### **REMARKS/ARGUMENTS**

Ser. No. 10/048,205  
Amdt. dated October 23, 2003  
Reply to Office action of April 23, 2003

FIG. 1

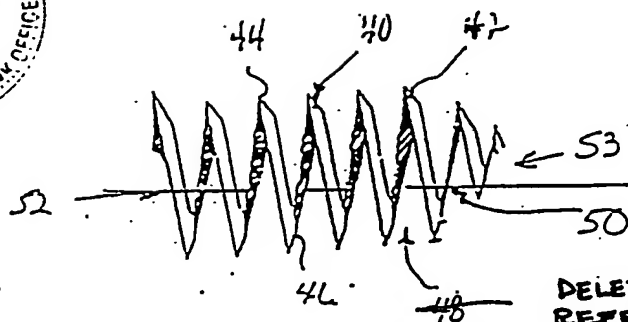
Regarding reference numerals shown in the drawings that are not present in the specification, element 48 has been deleted from FIG. 1 and element 94 has been

DELETE  
REFERENCE  
NUMERAL 48

FIG. 8B

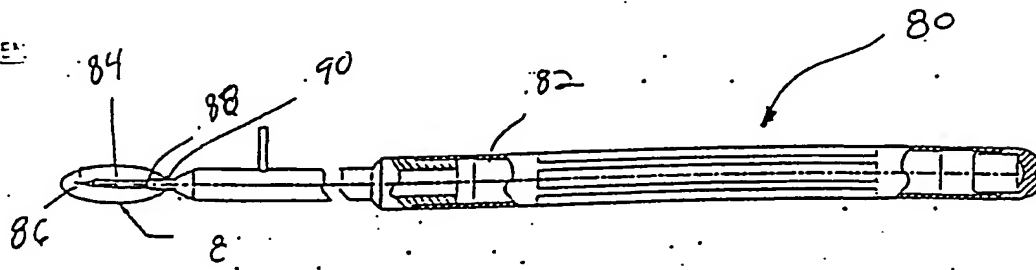
deleted from FIG. 8B. Replacement drawing sheets are provided along with annotated sheets explaining the changes made in the drawings. Regarding the omission of elements 52 and 53 from the specification, an amendment has been made at page 5, line 31 to insert a reference to the proximal and distal portions of the implant 52 and 53, respectively. Support for the inserted language defining proximal and distal portions is found at page 3, lines 3-4 of the application.

DELETE  
REFERENCE  
NUMERAL 94
